THE MEADOWS AT BAILEY CANYON

Specific Plan Changes

in Response to Planning Commission Feedback

JULY 7, 2022

SECTION A:
500 SUNNYSIDE AVE.
SIERRA MADRE, CA 91024

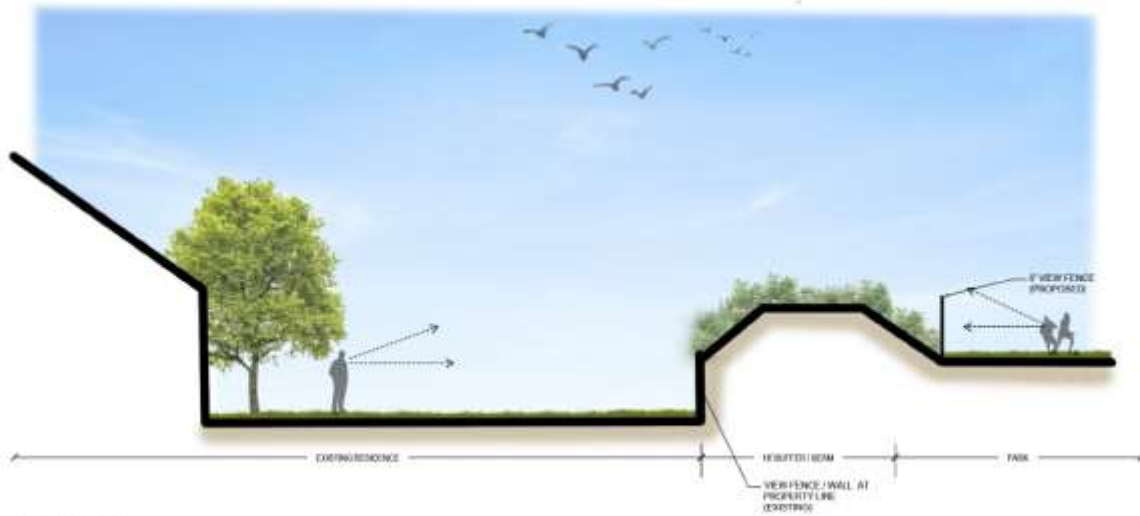
2. Eliminating trees within the park buffer

To preserve views, shrubs will be used for landscaping
